SERVICE BULLETIN

APPLICABILITY: 2011-2014MY Forester Models with FB Engine

NUMBER: 02-131-12R

SUBJECT: Oil Seepage Diagnosis and Repair Procedures

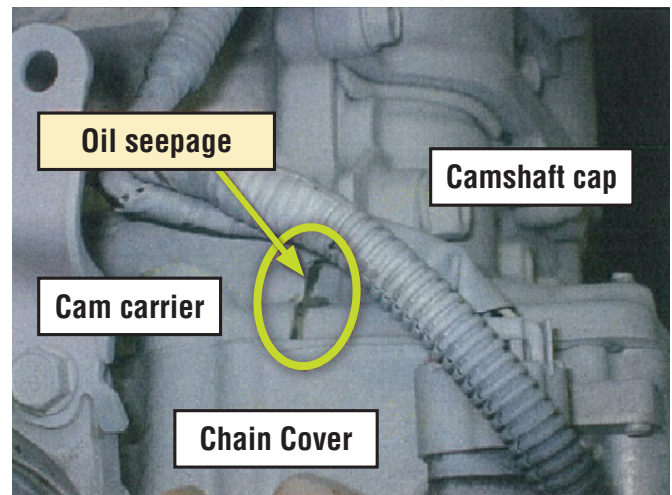
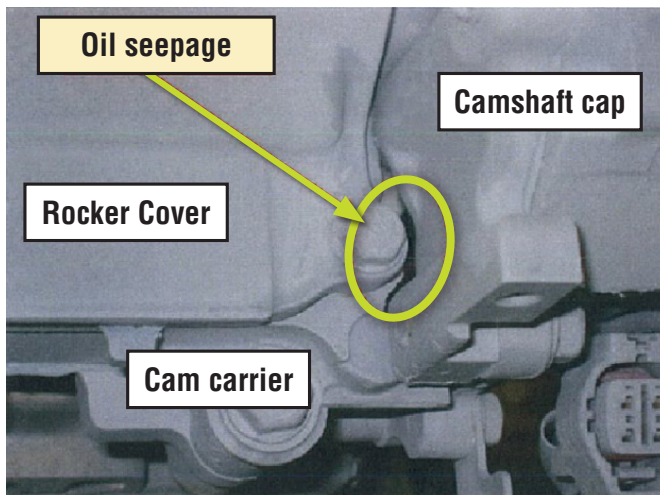
If oil seepage is verified coming from the 6mm threaded hole in the left-hand camshaft cap, install the specified bolt and flat washer.

Bolt: Part# 800206180

Washer: Part# 031106000

Tightening Torque: 6.4 +/- 0.5 Nm
 (57 +/- 4 inch-pounds)

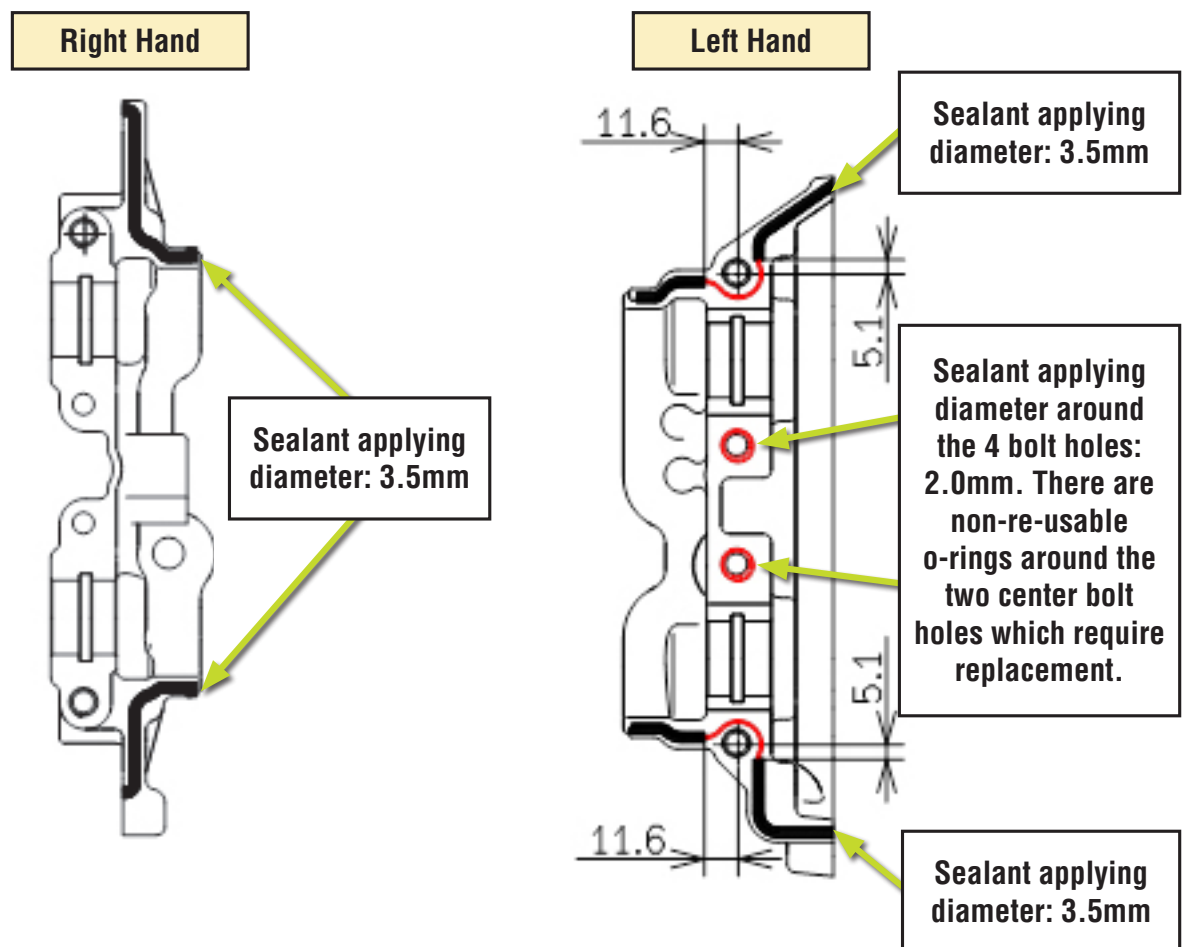
If oil seepage is verified coming from the front camshaft cap or cam carrier as shown in the photos below, remove the cam cap and clean both surfaces thoroughly before applying sealer. **Note:** The 2 o-rings between the camshaft cap and the cam carrier will need to be replaced as they are not re-usable.

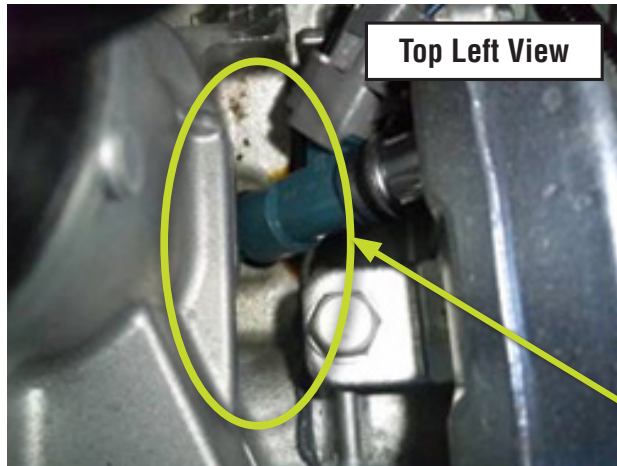
Apply Liquid Gasket, ThreeBond 1280B, (Part No. SOA5499100) or equivalent* as shown below:

Cam carrier seepage seen from top left and lower right side of engine

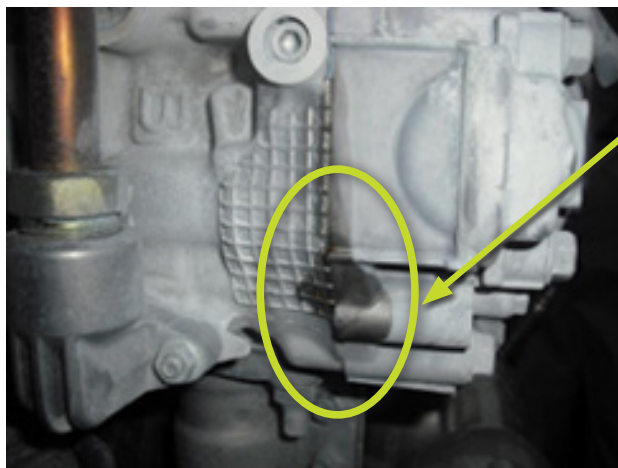
If oil seepage is verified coming from between the cam carrier and the cylinder head as shown in the photos below, remove the cam carrier. Clean the machined sealing surfaces thoroughly and then re-seal using Liquid Gasket ThreeBond 1280B, (Part No. SOA5499100) or equivalent*. As shown in the photos below, the o-rings between the cam carrier and the cylinder head will need to be replaced as they are not re-usable. This would also be a good time to clean the Active Valve Control System (AVCS) filter screens which are contained in the cam carriers. **NOTE:** The filter screens are one-time use and must be replaced if they need to be removed. The replacement filter part# is 14451AA050.

As viewed from the rear, oil seepage from the upper pan to engine block sealing area may be present in these areas.

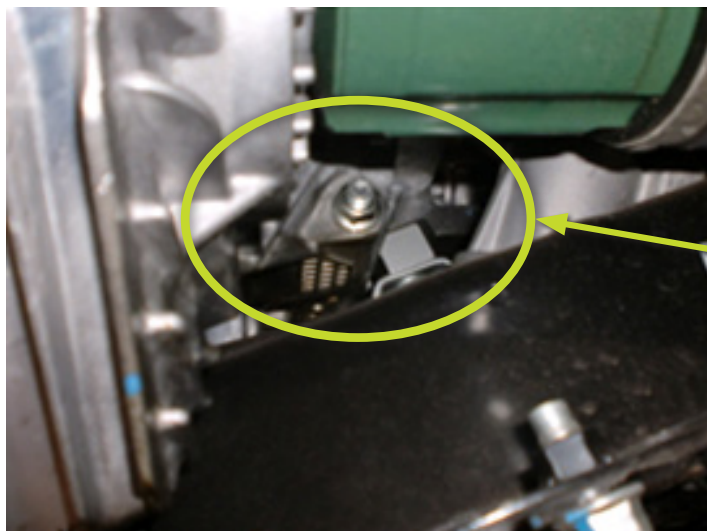
If you find engine oil seepage between the cylinder block and upper oil pan, remove the upper oil pan, clean the machined sealing surfaces thoroughly and then re-seal using Liquid Gasket ThreeBond 1280B, (Part No. SOA5499100) or equivalent*. **Note:** The o-rings between the upper oil pan and the cylinder block along with those between the upper and lower oil pan will need to be replaced as they are not re-usable.
